**Tyres – Regulations Nos. 30 and 54 (Pneumatic tyres)**

### **Proposal for amendments to Regulation No. 54 (Pneumatic tyres for commercial vehicles and their trailers)**

#### **Submitted by the experts from the European Tyre and Rim Technical Organization \***

Annex 3, arrangement of tyre markings, insert a new marking to read:

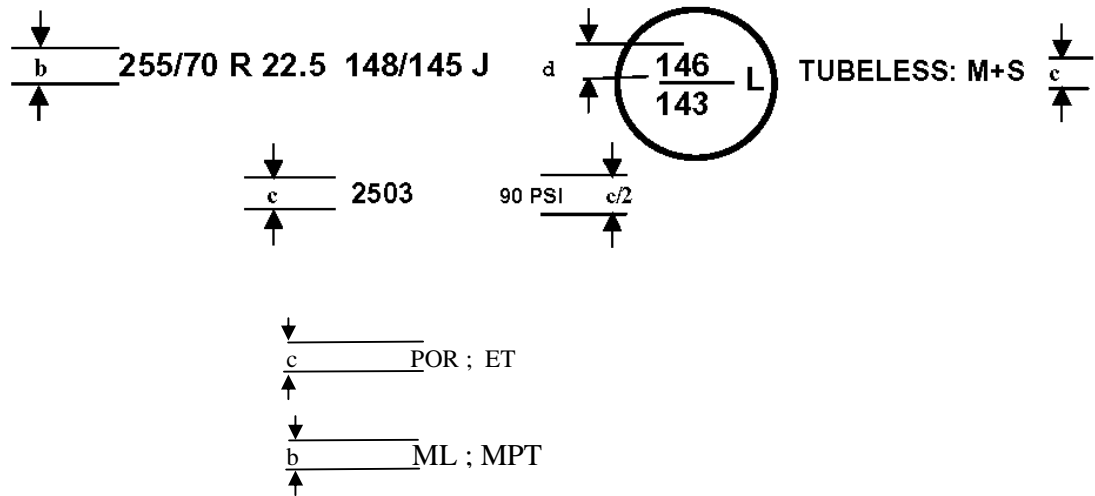
"

....."
